## ADDENDUM 001 Request for Bid Watson Truck Inspection Building RFB 9-170425SB

WATSON TRUCK INSPECTION BUILDING  
Northwest District - Atchison County  
124181, I-29 South, 64496

**A**  
**2** DEMOLITION PLAN  
SCALE: 1" = 30'-0"

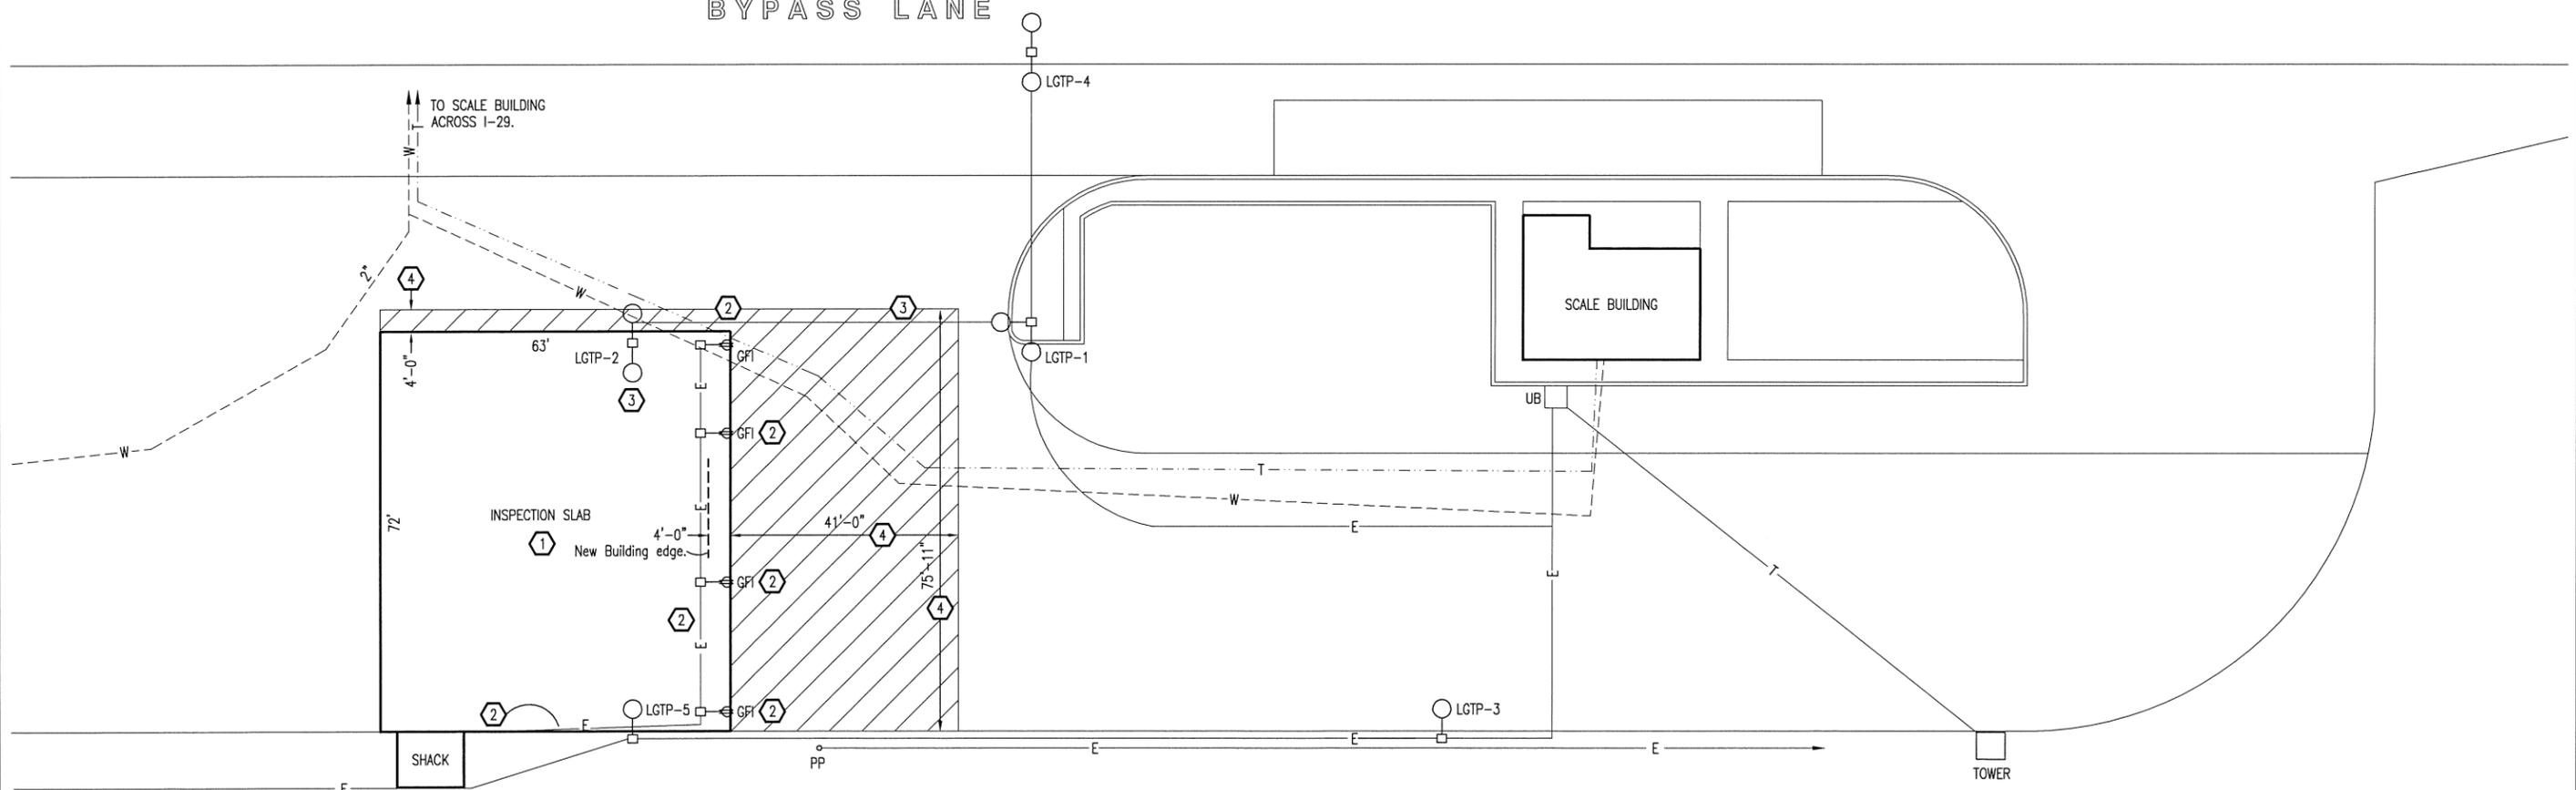
ADDENDUM #1 - SEE SHEET 4, DEMOLITION NOTE #4.

ADDENDUM #1 ④ CONTRACTOR TO REMOVE EXISTING 8" CONCRETE SLAB SHOWN HATCHED AND REMOVED OFF SITE PRIOR TO CONSTRUCTION OF NEW BUILDING. DIMENSIONS SHOWN. ESTIMATED 83± CUBIC YARDS.
